RE: REVISED DRAINAGE PLAN FOR LOT 33-A OF CLIFFORD INDUSTRIAL  
PARK (C-17/D1A5) REVISION DATE OF JANUARY 18, 1988

GRADING AND DRAINAGE PLAN  
LOT 33-A, CLIFFORD INDUSTRIAL PARK

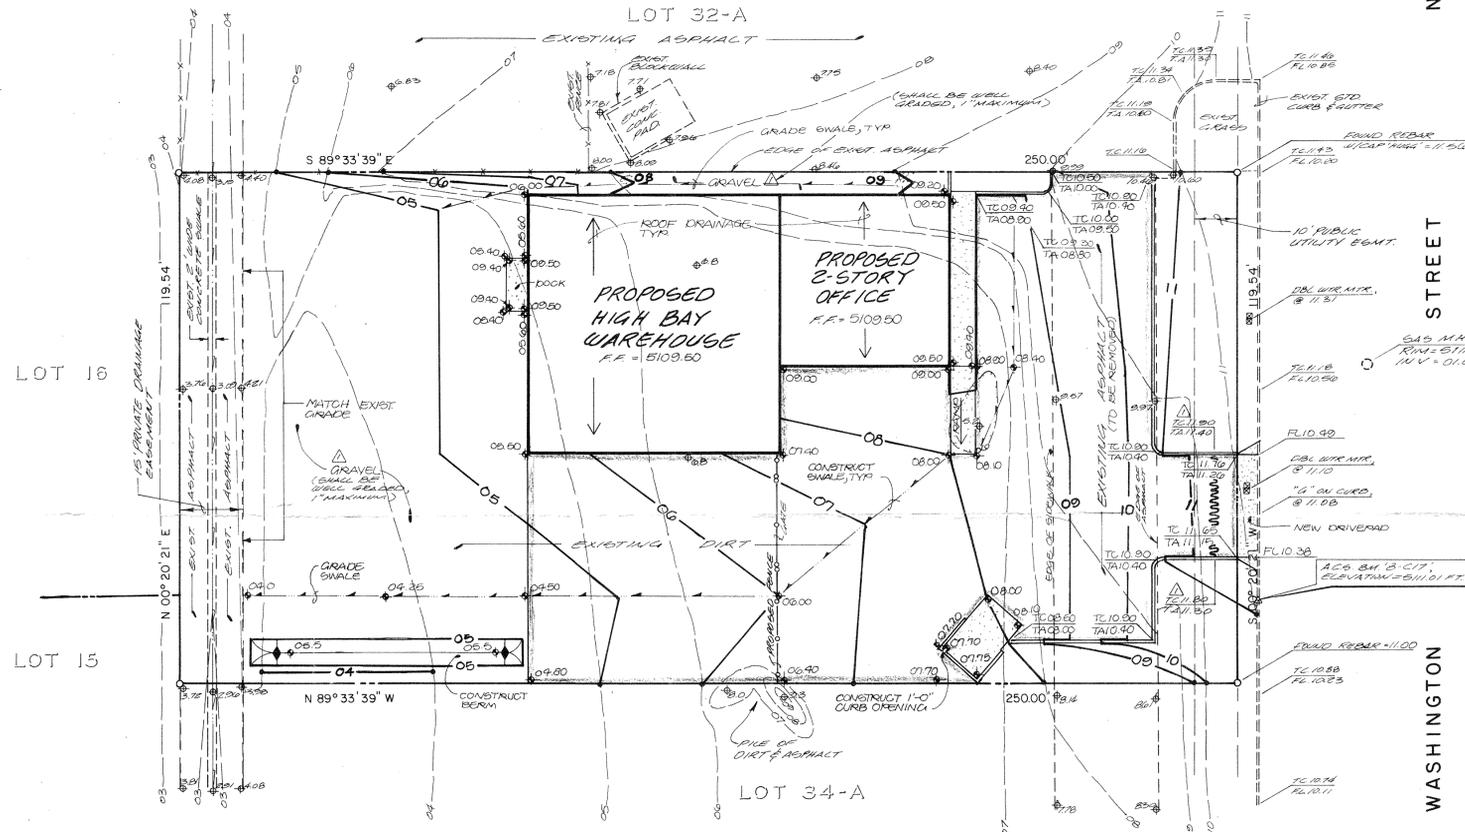
Based on the information provided on your resubmittal of January 18,  
1988, revisions as indicated are acceptable.

Please attach a copy of this plan to the construction sets prior to  
sign-off by Hydrology.
